## DOCUMENT CHANGE REQUEST

DCR number 266 Changes required for: General

Title: Transistors Low Power RF NPN, based on type 2N3019

Number: 5201/011

**PHYSICAL DIMENSIONS AND TERMINAL IDENTIFICATION**

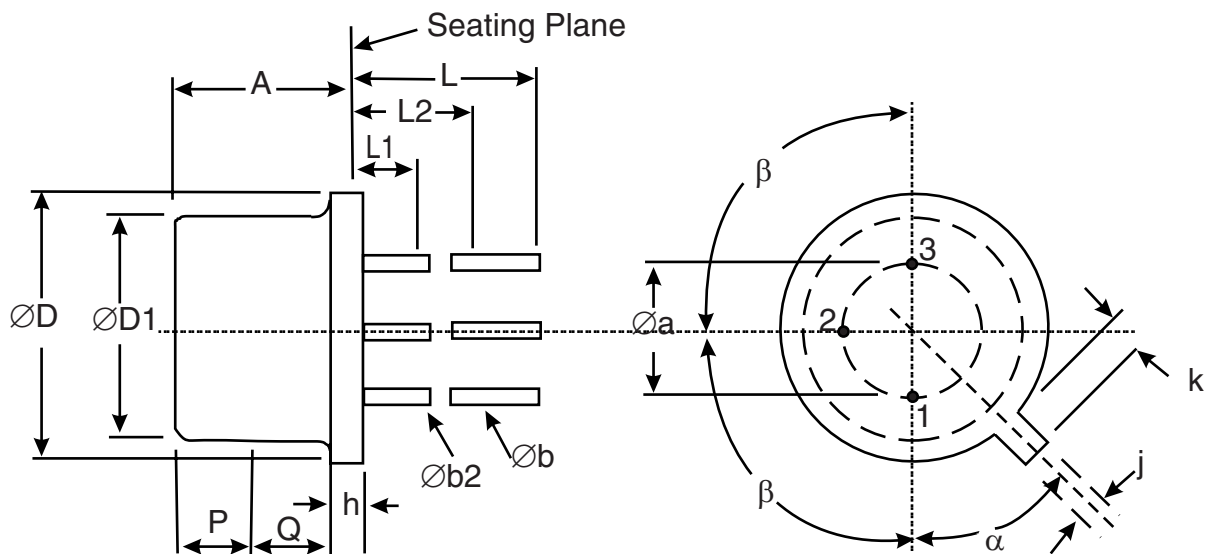
6. Figure 2 - Dimensions .a. and .b. corrected from "NOMINAL" to "BSC". The drawing harmonized with TO-39 outlines for similar STM components.
7. Para 4.3.2 - Weight requirements moved to Component Type Variants table.

VOLTAGE WAVEFORMS

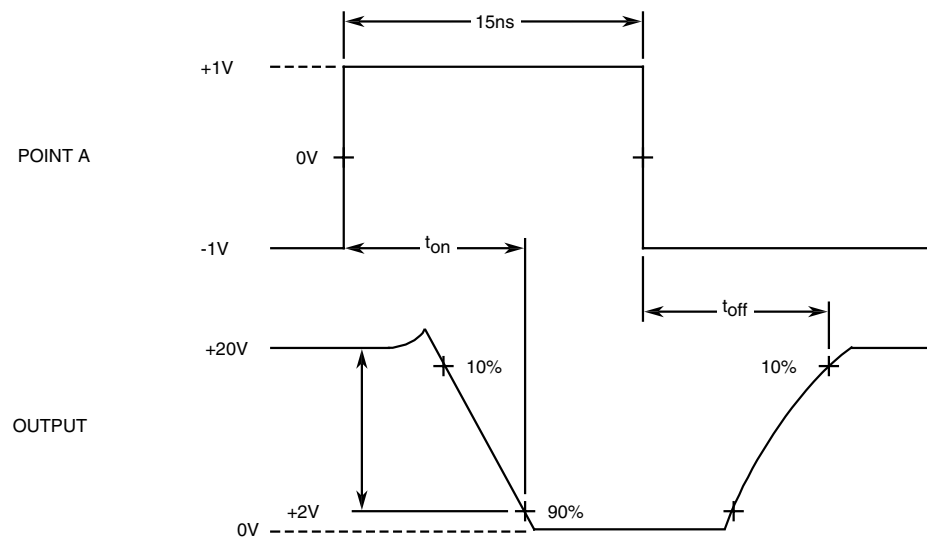
14. Table 2 . The test condition for tCB corrected from VCE to VCB to align with the MIL specification test definition.
  15. Table 2 and Figure 4 - For tON and tOFF tests a new Note 4 added which fully defines the tests based upon the test circuits and conditions used by STM and MIL specification, showing the test circuit and the corrected waveforms.

1. Pulse measurement: Pulse Width  $\leq 300\mu s$ , Duty Cycle  $\leq 1\%$
2. For AC characteristics read and record measurements shall be performed on a sample of 32 components with 0 failures allowed. Alternatively a 100% inspection may be performed.
3. This parameter is measured by applying an RF signal voltage of 1Vrms across the collector-base and measuring the ac voltage drop ( $V_{eb}$ ) using a high impedance RF voltmeter across the emitter-base. The collector-base time constant is then calculated as follows:  $\tau_{CB}$  (in ps) = 2 x  $V_{eb}$  (in mV)
4. Pulse response shall be measured using the following test circuit. The input waveform shall be supplied by a pulse generator with the following characteristics:  $Z_{OUT} = 50\Omega$ ,  $t_r \leq 2ns$ , Duty Cycle  $\leq 2\%$ . The output waveform shall be monitored on an oscilloscope with the following characteristics :
